SECTION 009113 – ADDENDUM TWO

- A. Project Name: Alliance Fire Station
- B. Owner: Madison County
- C. Architect: Dale Partners Architects, PA
- D. Architect Project Number: 22019
- E. Date of Addendum Two: 1 November 2022

1 SECTION AT SLAB RIB

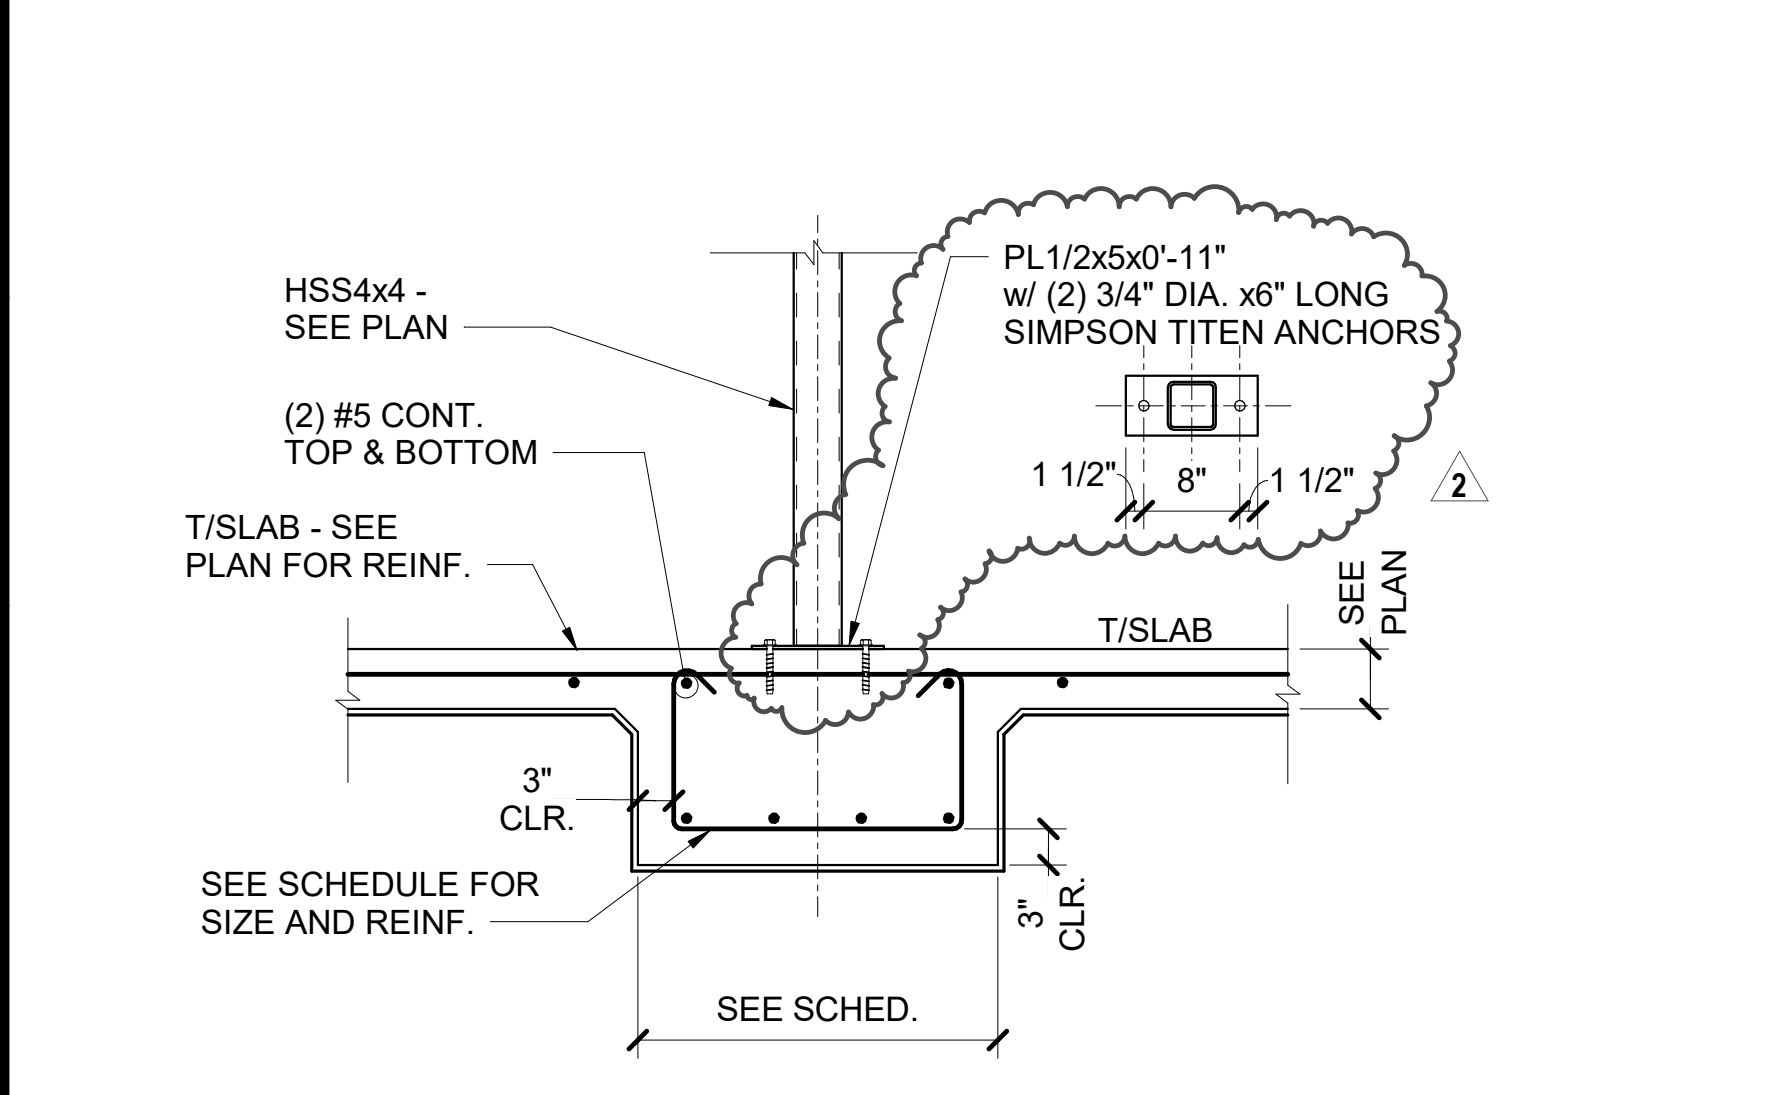
- F. Structural Sheet S-302 – FOUNDATION SECTIONS AND DETAILS. Delete the sheet in its entirety and replace with the attached. Revised Section 1 to detail baseplate with post-installed anchors at interior columns.

2 SECTION AT ROOF

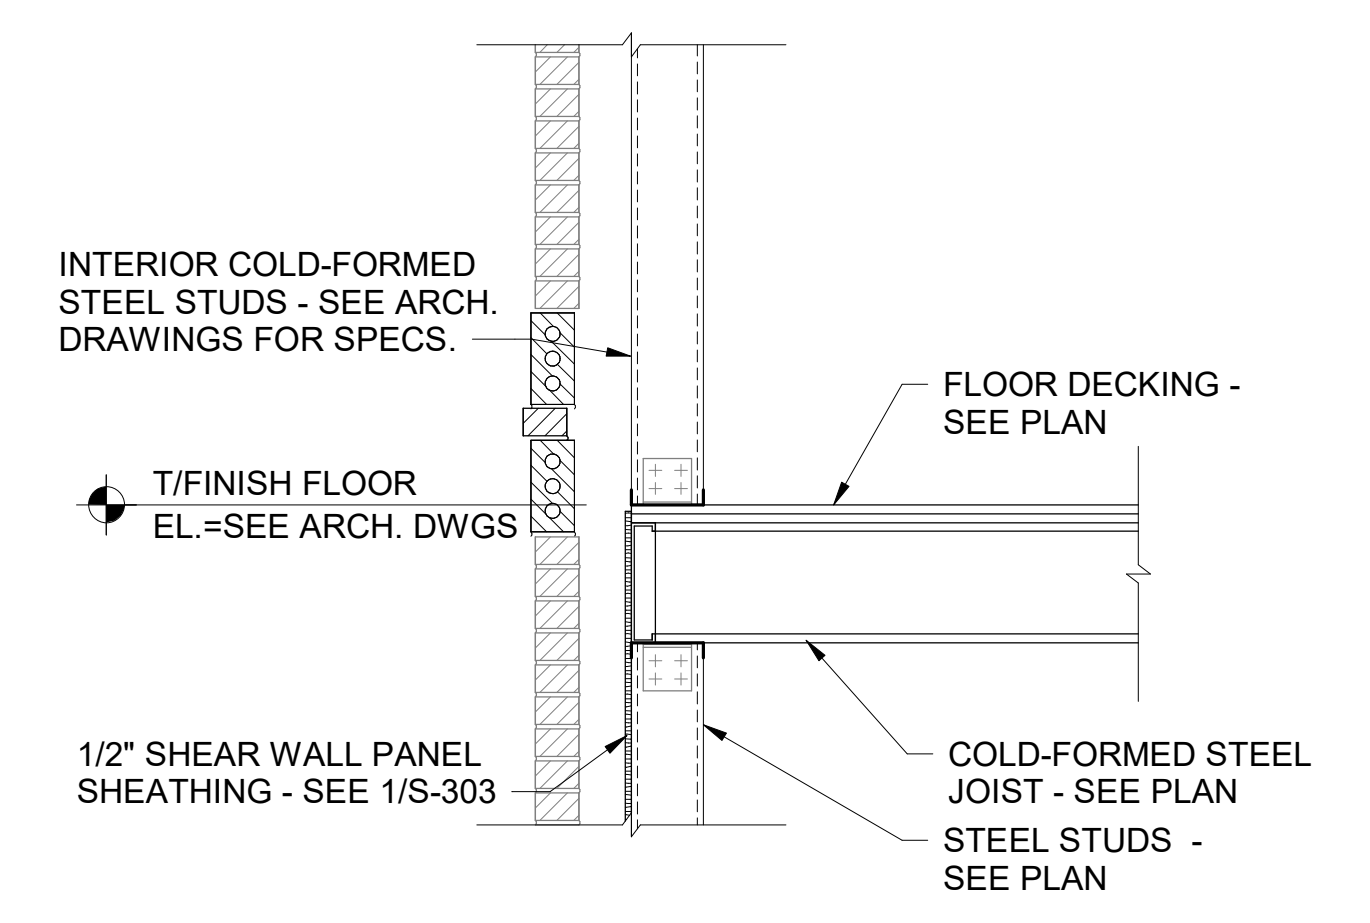
- I. Structural Sheet S-403 – FRAMING SECTIONS AND DETAILS. Delete the sheet in its entirety and replace with the attached. Added details 2 and 3.

1 FLOOR FRAMING SECTION AT MEZZAINE

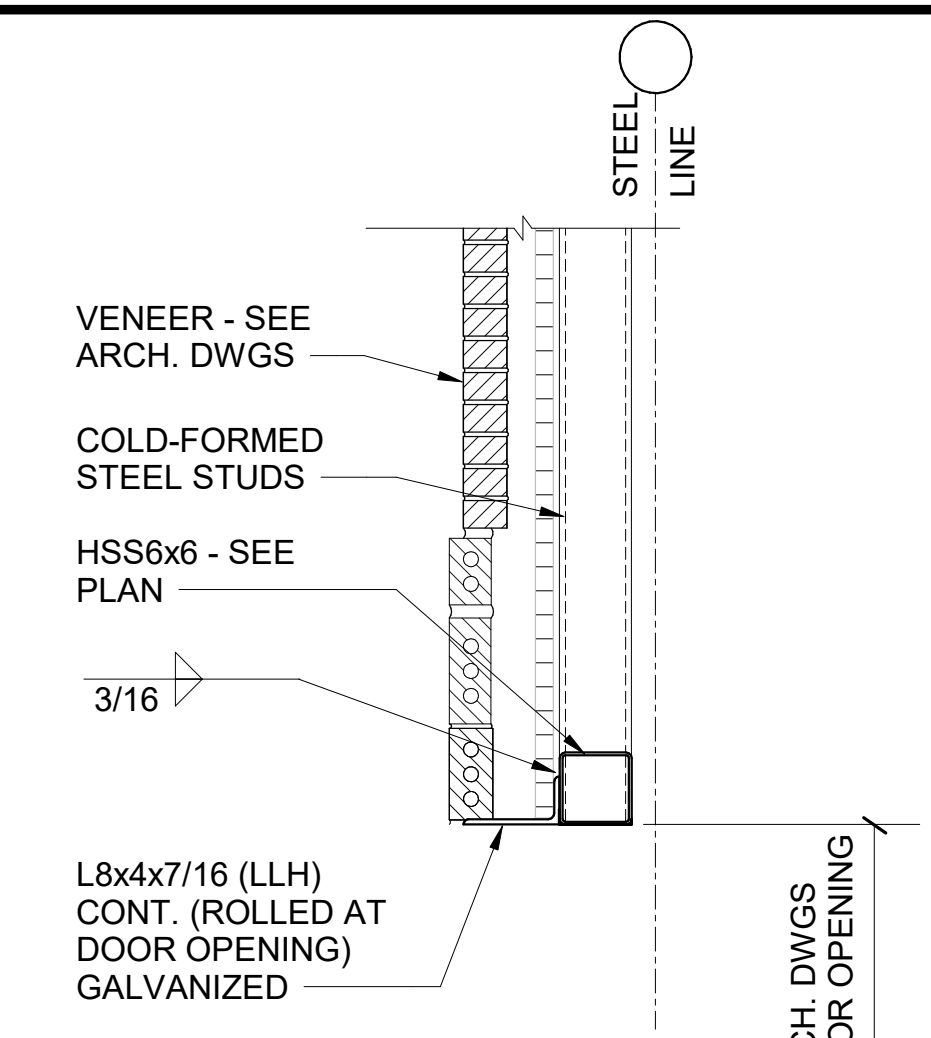
- D. Structural Sheet S-102 – MEZZANINE FRAMING PLAN. Delete the sheet in its entirety and replace with the attached. Added Sections 7/S402, 2/S-403 and 3/S-403.
